Dear reader,

- this piece of work is focussed on rewriting the frontal and rear impact;
- to keep an overview nothing of the old text is deleted but in strikethrough characters;

Hans Ammerlaan - NL MOT/RDW

8. DESCRIPTION OF TESTS ^{3/}8.1.3. Dynamic tests - for frontal, rear and side impact

Figure 1

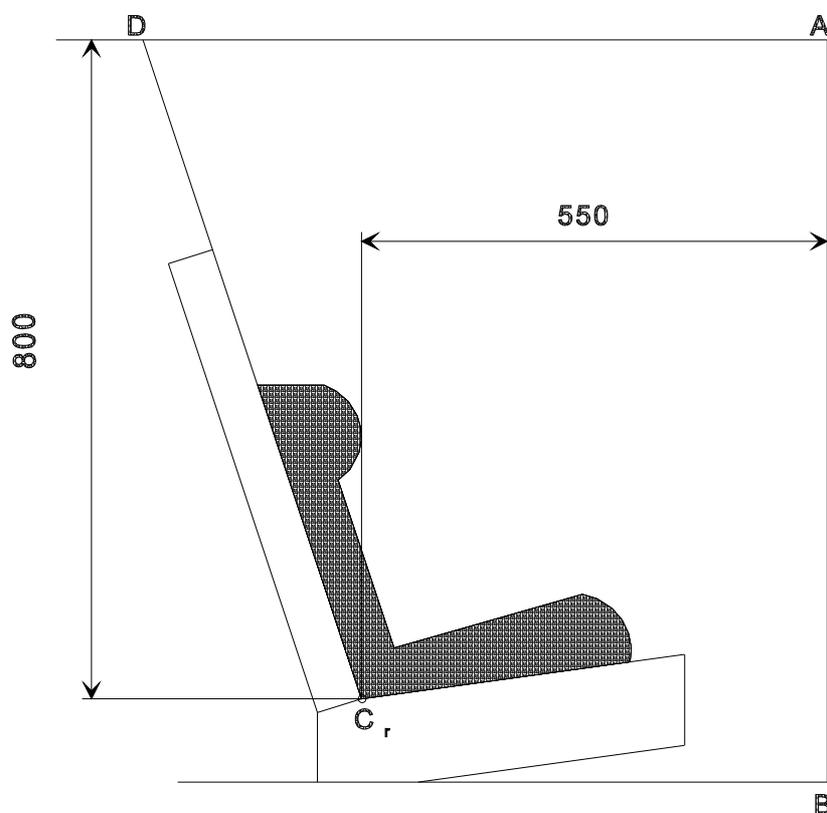
Head excursion: no part of the head of the manikin shall not pass beyond the planes BA, and DA and DE as defined in Figure 1 below. This shall be judged up to 300 ms or the moment that the manikin has come to a definitive standstill whatever occurs first.

Remark: as is the case with rearward facing child restraints, the point E being the top of the seat back of the R.44 seat should also be defined here.

Furthermore, because it concerns ISOFIX child restraints, the forward excursion limit shall have to be changed from 550 mm to 500 mm.

Finally, the 800 mm vertical limit shall have to be connected to only testing with Q0, Q1, Q1.5, Q3 and Q6, whilst for testing with Q10 a vertical limit of 840 mm will be used.

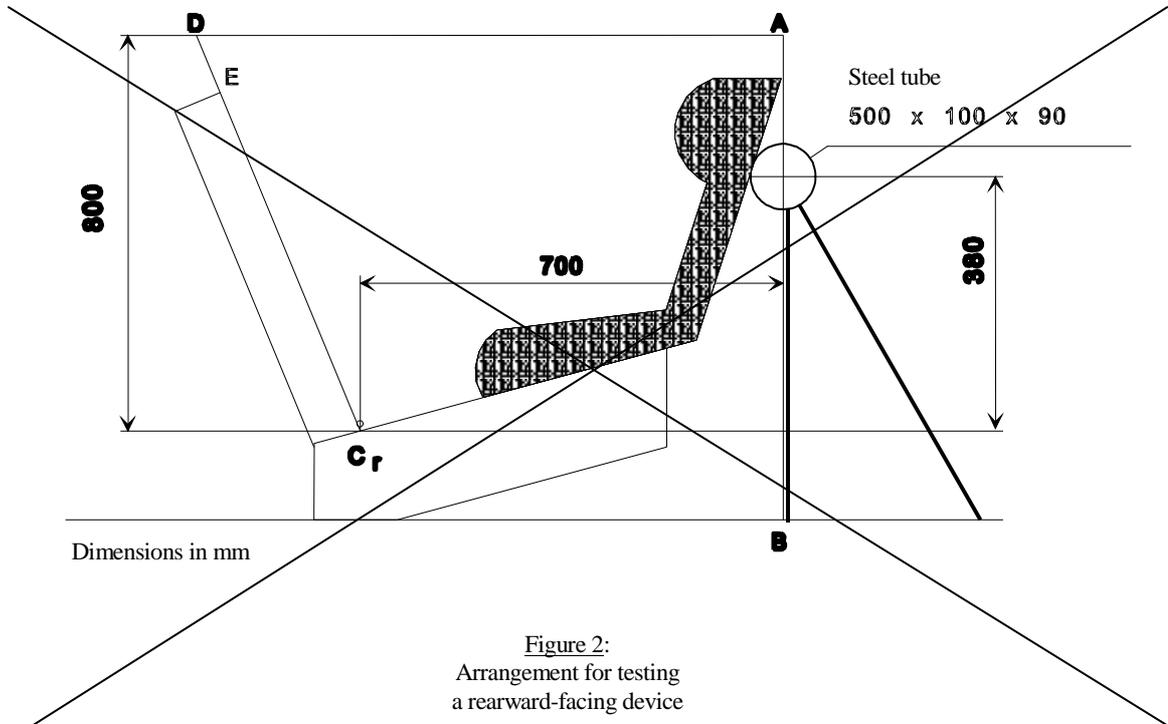
Remark: figure below with support by dashboard not needed anymore must be deleted

Figure 3

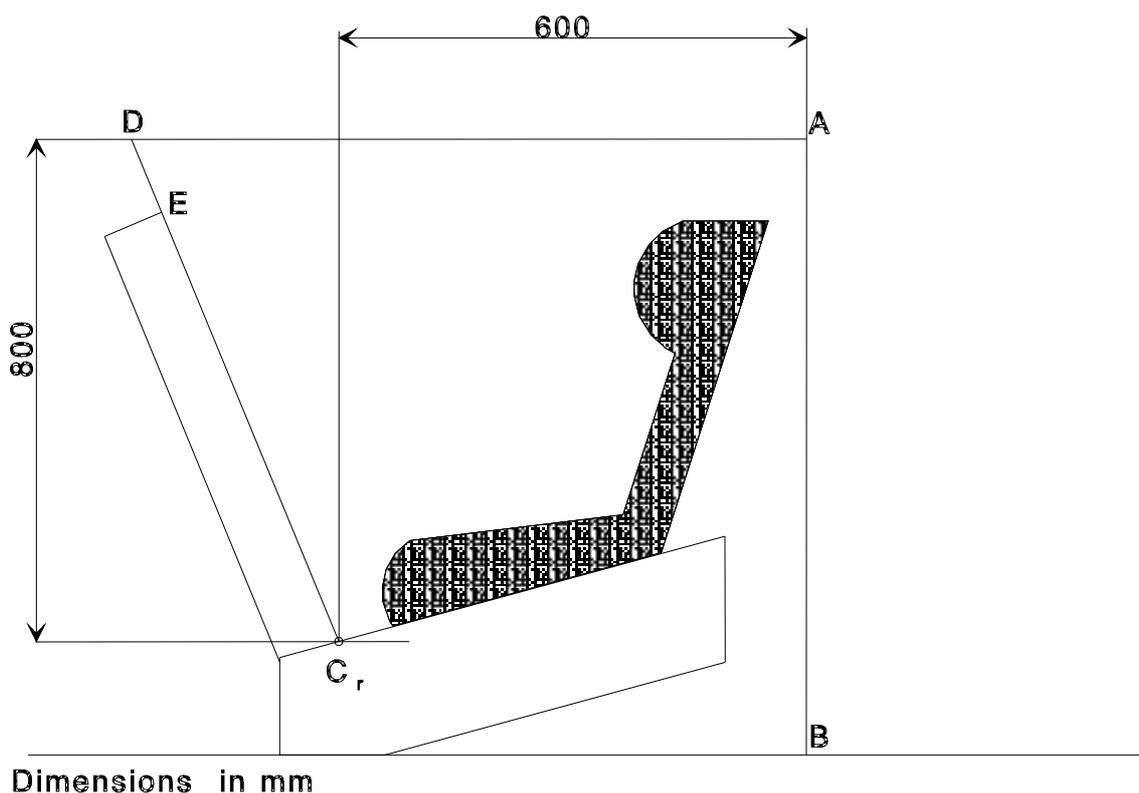
Remark: figure below with distance of 600 not needed anymore must be deleted

Figure 4:

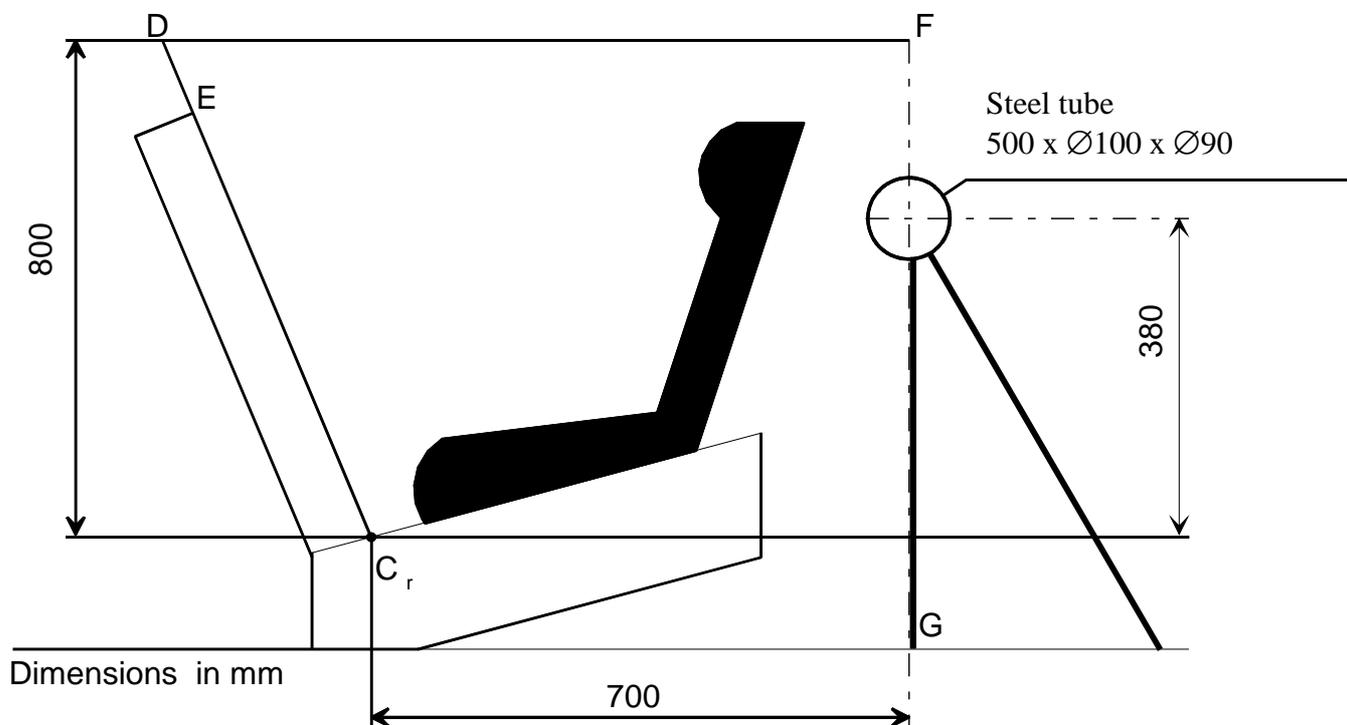
7.1.4.4.1.2.2. Head excursion: no part of the head of the manikin shall pass beyond the planes FD, FG and DE, as shown in Figure 4 below. This shall be judged up to 300 ms or the moment that the manikin has come to a definitive standstill whatever occurs first.

In the case there is a contact of such a child restraint with the 100 mm diameter bar and all performance injury assessment and manikin's head displacement criteria are met, there shall be one further dynamic test (front impact) with the heaviest dummy intended for such child restraint the given iSize indication and without the 100 mm diameter bar; the requirements for this test are that all criteria other than forward displacement the criteria of paragraph 7.1.4.2. (child restraint integrity) and paragraph 7.1.4.4.1.2.1. (head exposure) are met.

Remark: now from the point of view that a distance from Cr point to dashboard of 700 mm will be an accepted measure, it should be safeguarded that front passenger car seats can offer this space (after normal adjustment of the seat).

Annex 7 - Appendix 1CURVE OF TROLLEY'S DECELERATION OR ACCELERATION,
AS FUNCTION OF TIME**FRONTAL IMPACT****Definition of the different curves**

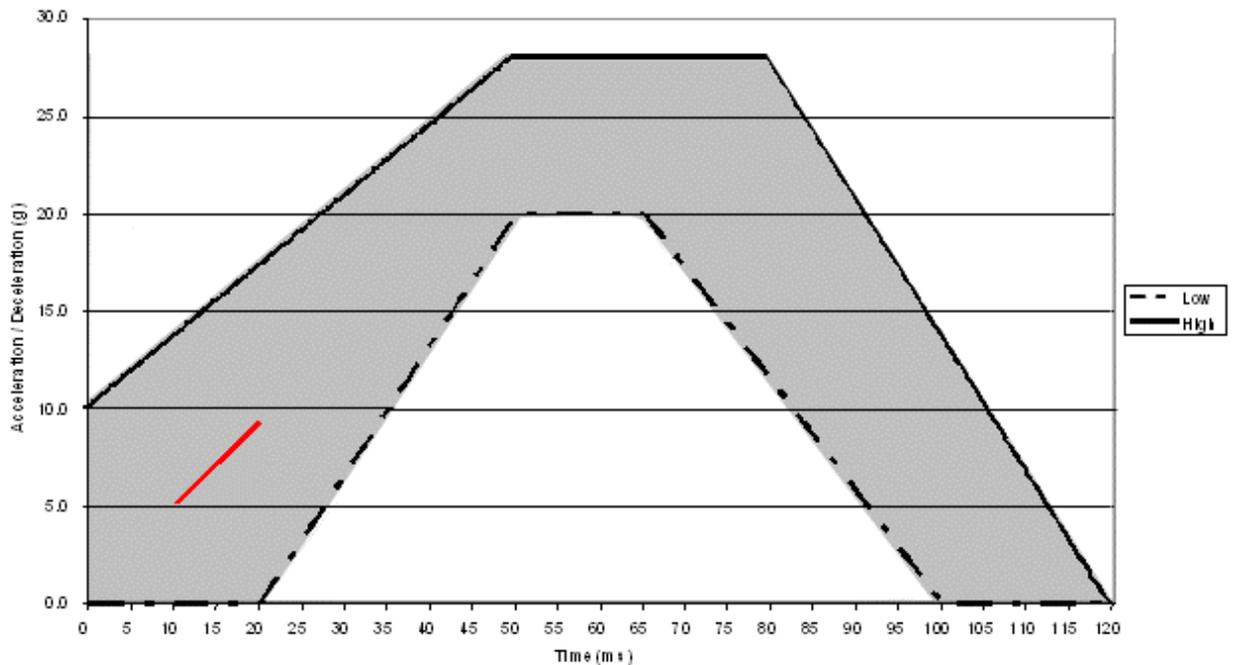
For frontal impact, the trolley shall be so propelled that, during the test, its total velocity change ΔV is $52 + 0 - 2$ km/h and its acceleration curve is within the hatched area of the graph in Annex 7, Appendix 1 and stay above the segment defined by the coordinates (5g, 10ms) and (9g, 20ms). The start of the impact (T0) is defined, according to ISO 17 373 for a level of acceleration of 0.5g.

The additional segment (see paragraph 8.1.3.1.1.3.2.) applies only for the acceleration sled

Annex 7 - Appendix 2CURVES OF TROLLEY'S DECELERATION OR ACCELERATION,
AS FUNCTION OF TIME**REAR IMPACT****Definition of the different curves**

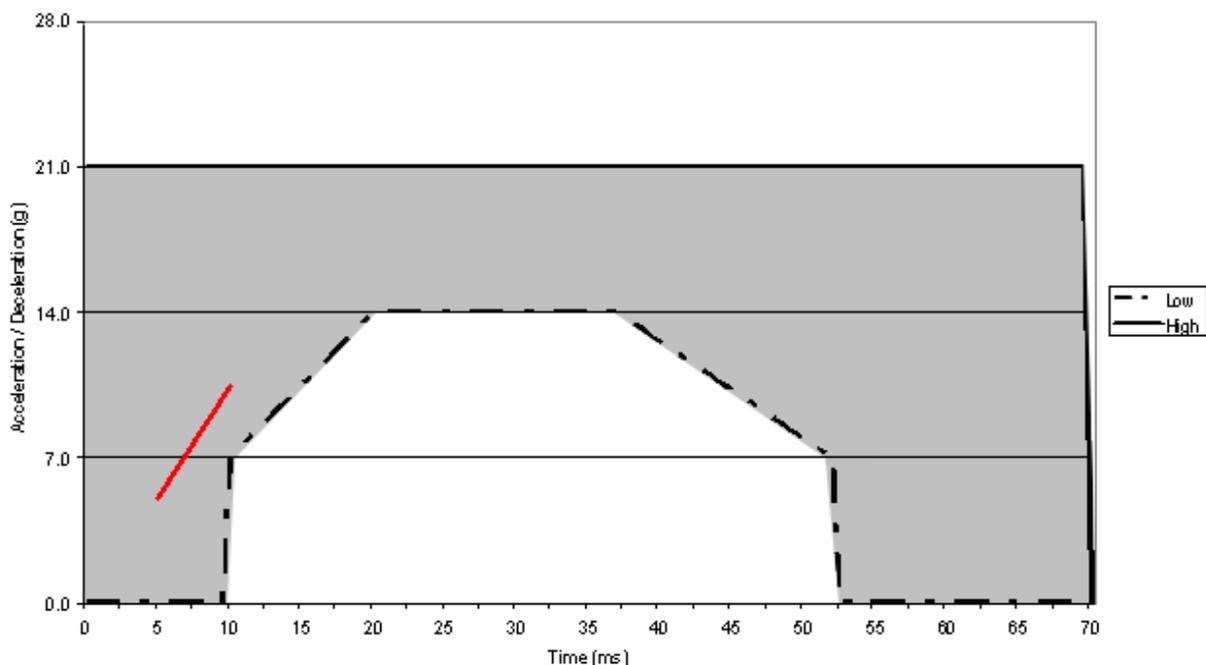
For rear impact, the trolley shall be so propelled that, during the test, its total velocity change ΔV is $32 + 2 - 0$ km/h and its acceleration curve is within the hatched area of the graph in Annex 7, Appendix 2 and stay above the segment defined by the coordinates (5g, 5ms) and (10g, 10ms). The start of the impact (T0) is defined, according to ISO 17 373 for a level of acceleration of 0.5g.

The additional segment (see paragraph 8.1.3.1.1.3.2.) applies only for the acceleration sled
